**ADDENDUM NO. 01**  
**Date: January 28, 2022**

To Drawings and Specifications dated December 6, 2021:

**HCC Renovations**  
**Central South, Eastside, Northeast, and Stafford Campuses**  
**Harris County, Texas**

Collaborate Project No.: 2135

**1 REFLECTED CEILING PLAN - HCC EASTSIDE**  
1/4" = 1'-0"

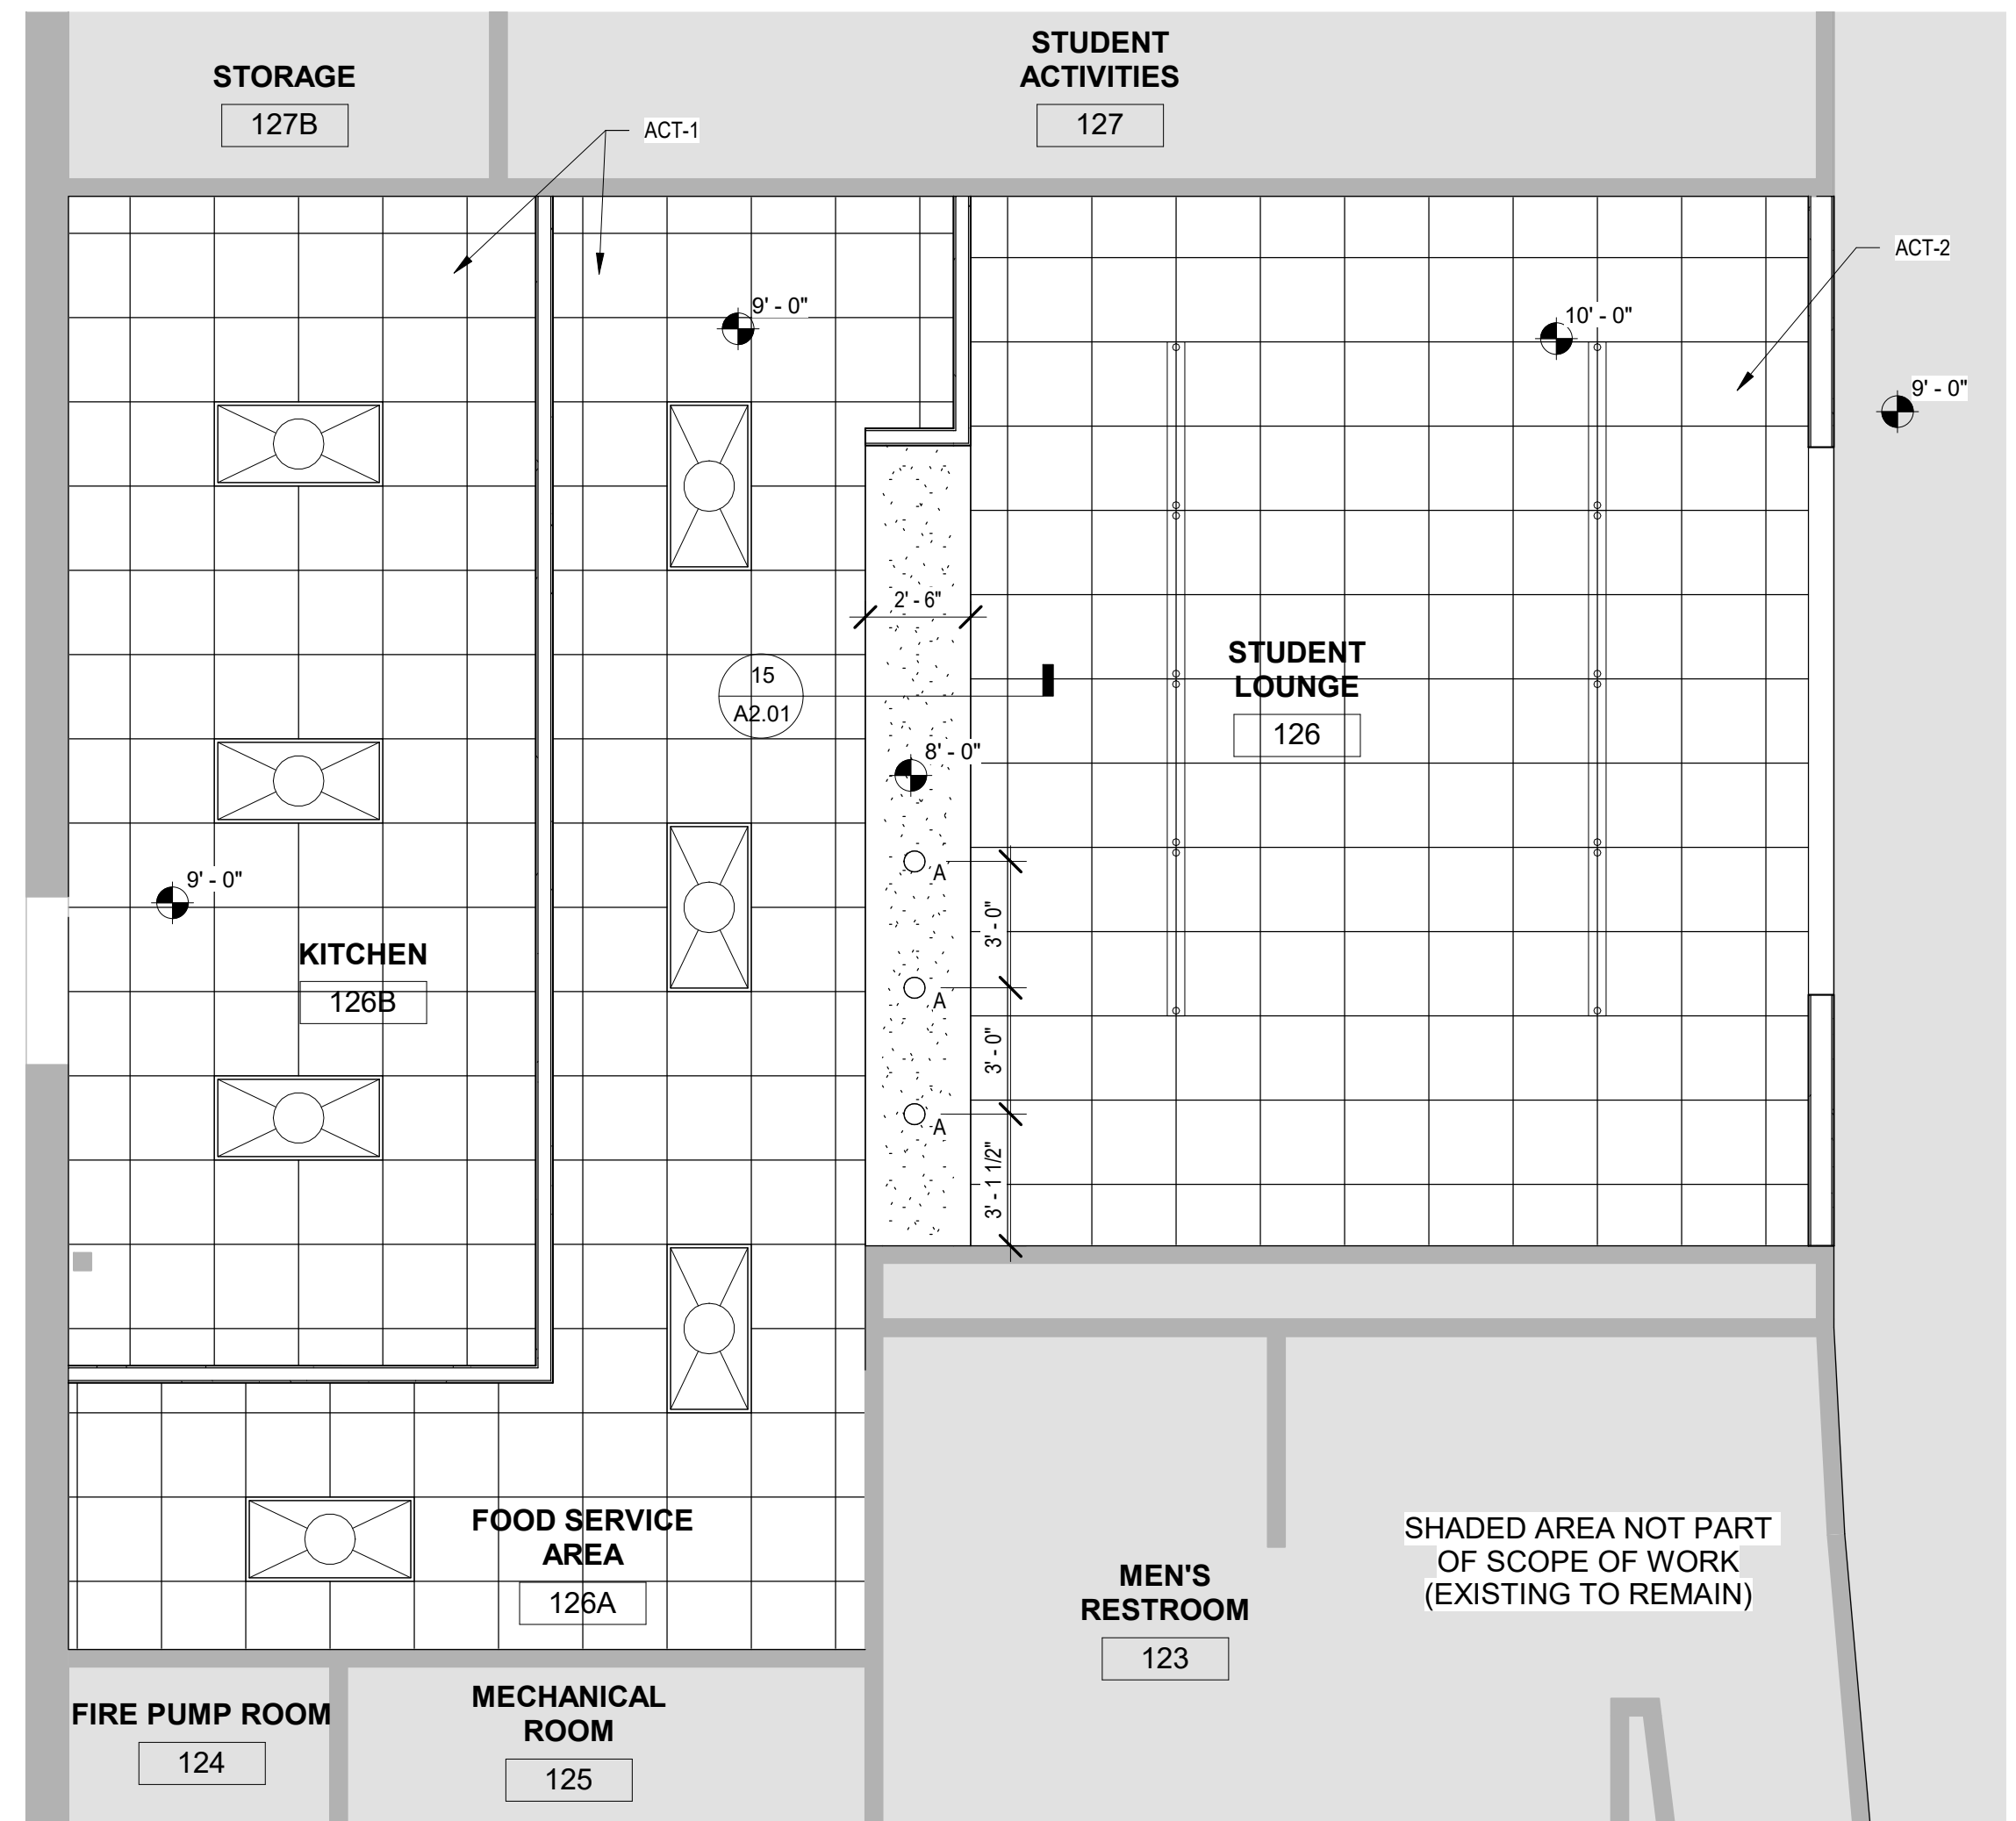
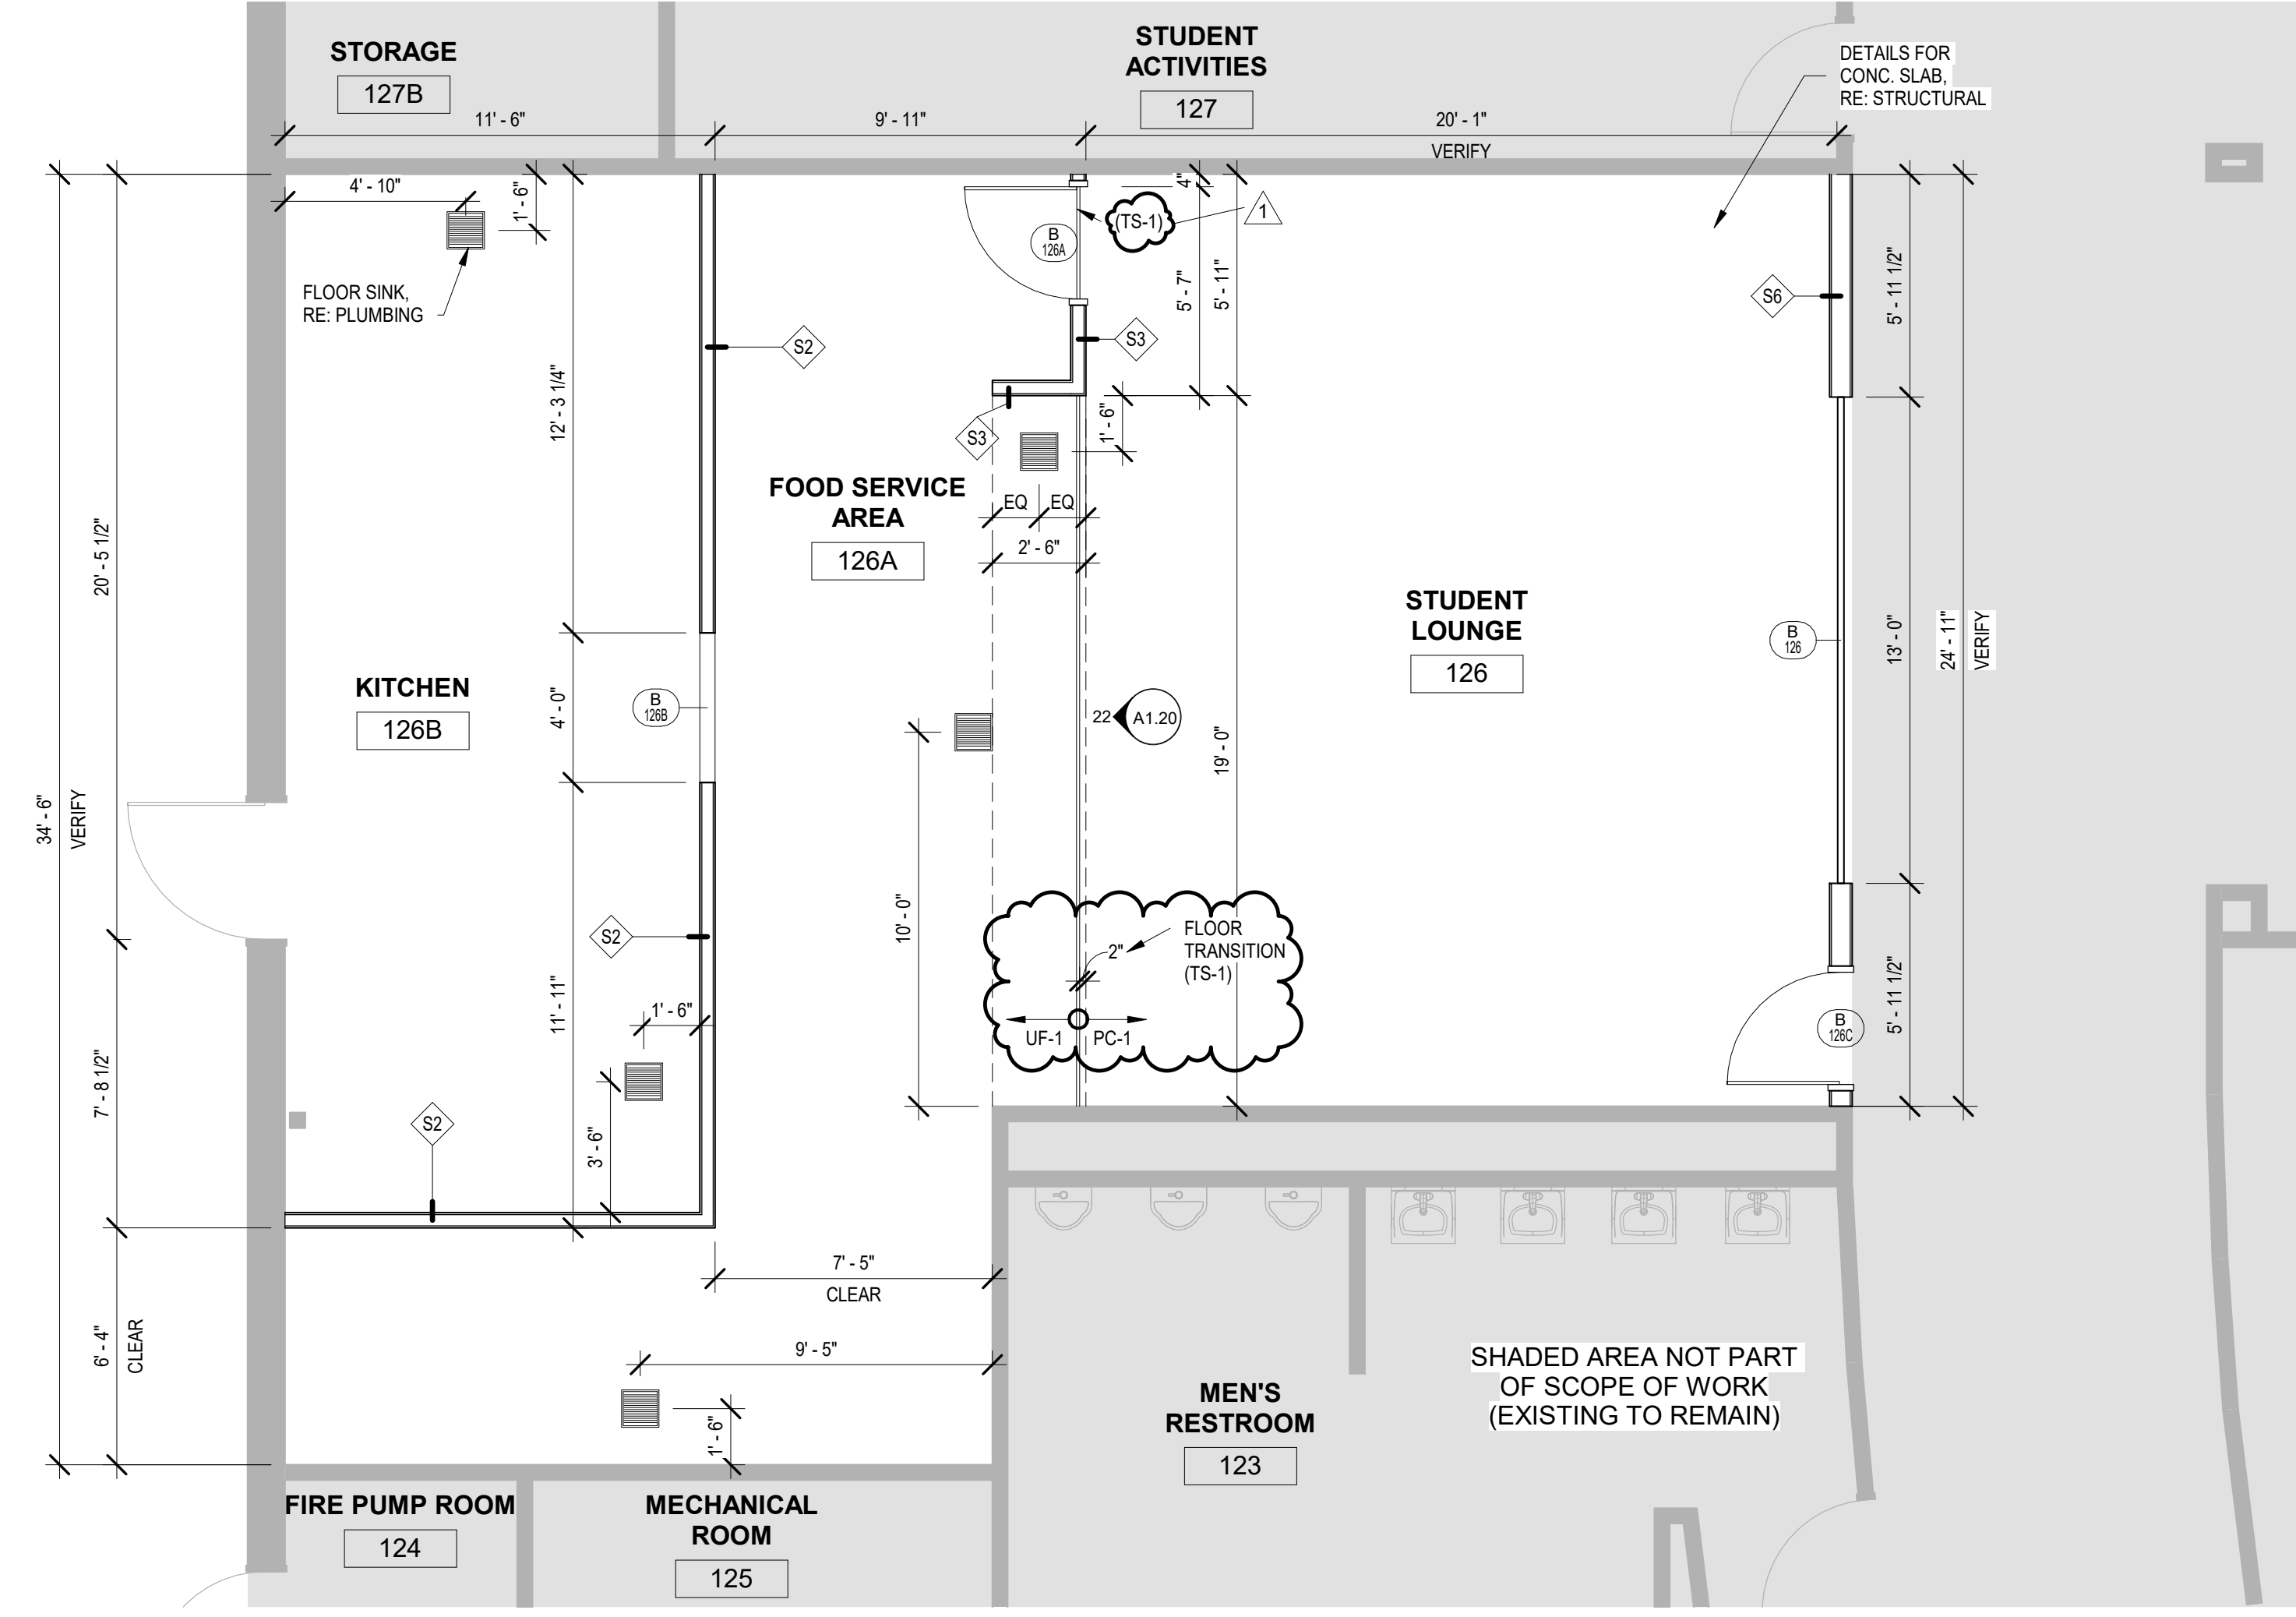
- Item No. 13 **Question:** At the Eastside campus, the Reflected Ceiling Plan drawing shows 9ft on Food Service Area Room 126A. We need to verify that the sprinkler line on wall coming from Mechanical and Fire Pump Rooms will be above ceiling grid. Addition to scope of work may be needed to adjust if needed.

**Response:** Adjust the sprinkler pipe as required to provide a 9'-0" ceiling height.

**29 WAINSCOTT AND TERRAZZO BASE LOCATION**  
 1/8" = 1'-0"

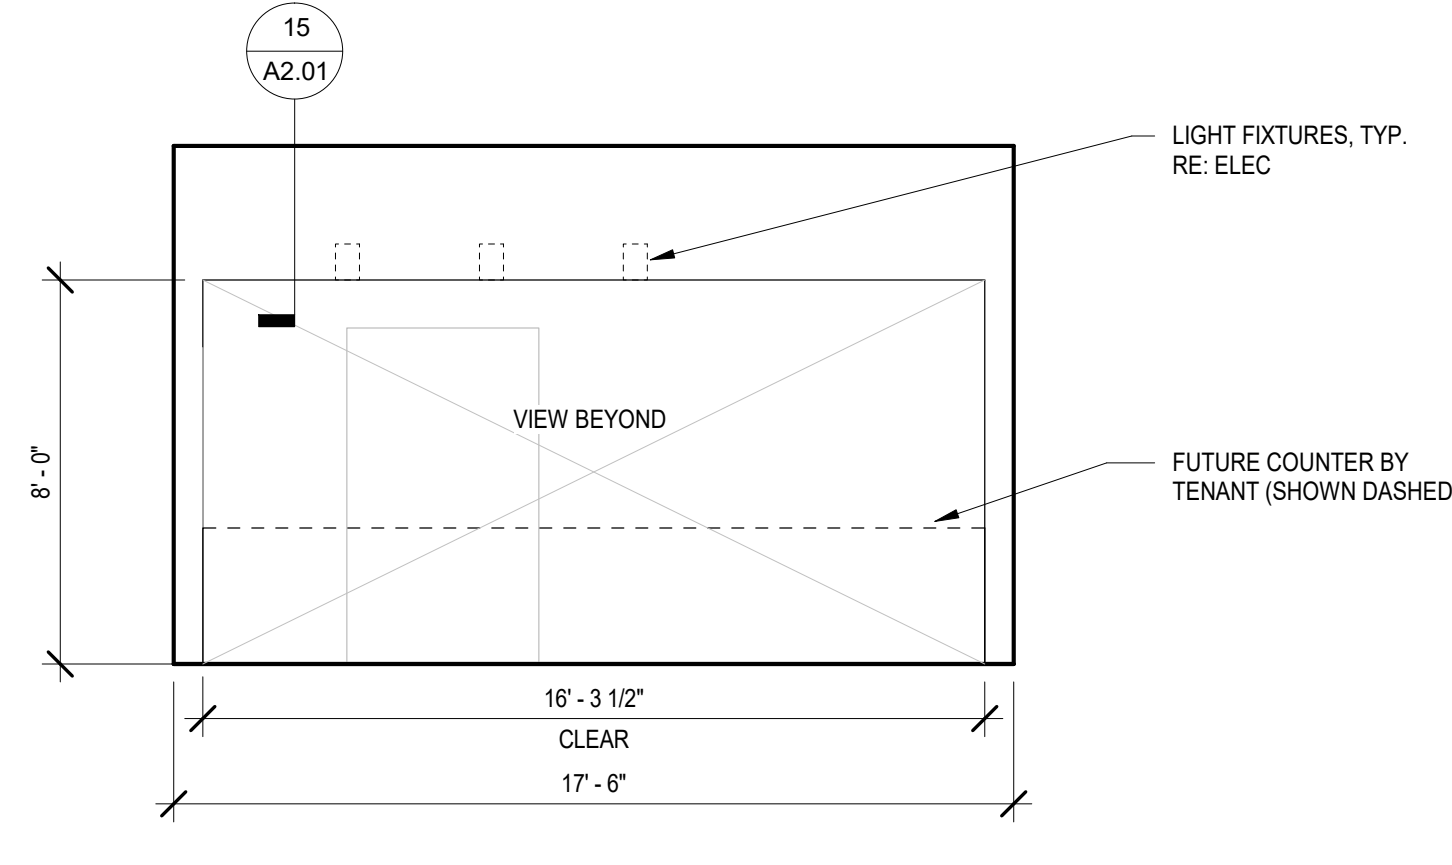
**Response:** Replace all VCT flooring in the Student Lounge. Refer to attached Drawing A1.10 for the new pattern and VCT description.
- Item No. 12 **Question:** At the Stafford campus, does client want to add FRP to new partition walls in order to match to existent wall design around the rest of the building. Do we simply build new partitions with finish paint schedule?

**Response:** Provide plastic laminate clad plywood on a 4" terrazzo base with an aluminum Schluter trim at the top to match the existing wainscot. Match existing plywood thickness and provide a 1"x1" stainless-steel corner bead with exposed fasteners to match existing. Refer to attached Drawing A1.40 for the location of the wainscot panels. Paint partition from top of wainscot to ceiling.
